Academy at Anderson Creek 1112 - 173 Scholar Drive, Spring Lake, 28390  
 Harnett County  
 Created: 4/5/2021

House Plan: Mixon III  
 Elevation: A  
 Stone/Brick Option: Option #1 see MSS  
 Foundation: Crawl  
 Foundation Finish: 3 Sides Parged  
 Garage Hand: Right  
 Garage: 2 Car Front  
 Garage Door: (2) 8x8  
 Front Porch: Concrete  
 Roof: Truss  
 Siding: Fiber Cement  
 Ceiling Height 1st Floor: 9'  
 Ceiling Height 2nd Floor: 9'  
 Door Frame Height 1st Floor: 83"  
 Door Frame Height 2nd Floor: 83"  
 Windows 1st Floor: 6/0 Front only, 5/0 side&rear  
 Windows 2nd Floor: 5/0

**MIXON III**  
 PLAN NAME  
**B-2287-45GR**  
 PLAN I.D.  
**1-28-21**  
 DATE

**ELEVATION "A"  
 ROOF FRAMING PLAN  
 W/ BEDROOM #4 / BATH OPTION**  
 SCALE ----- 1/8"=1'-0"

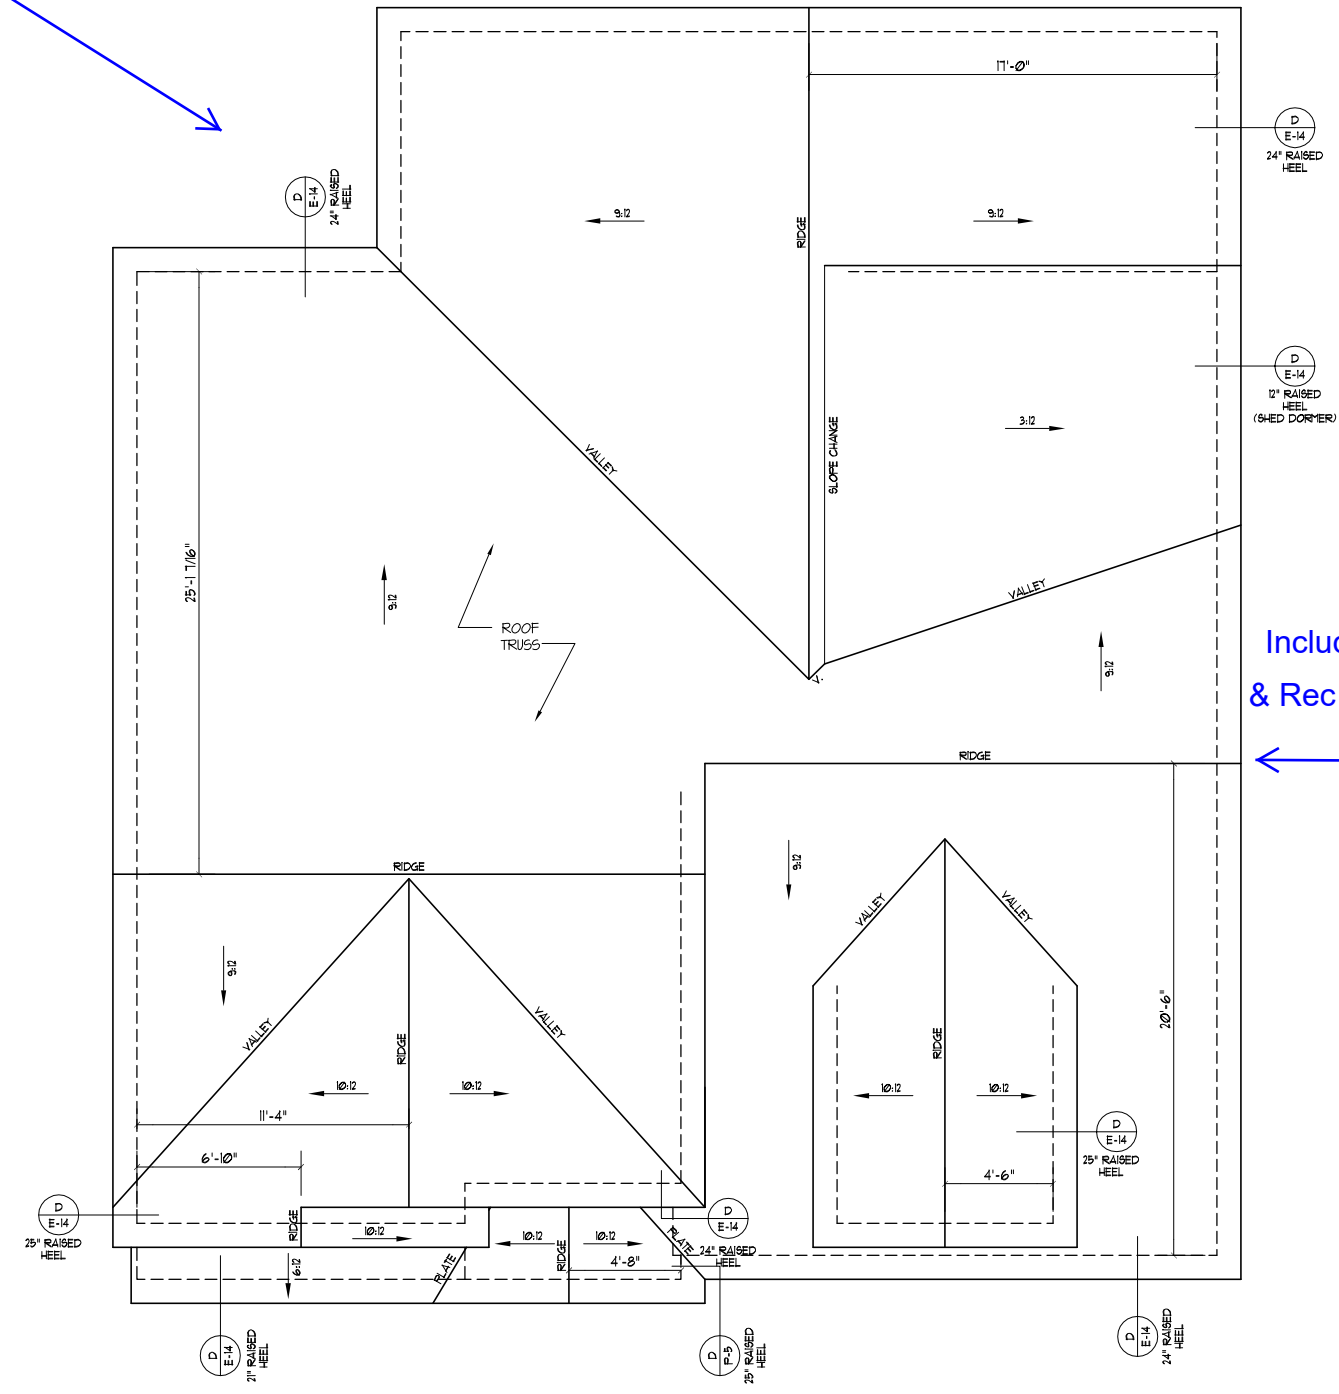
Include Screened Porch

Include Bedroom #4 & Rec Room and Closet
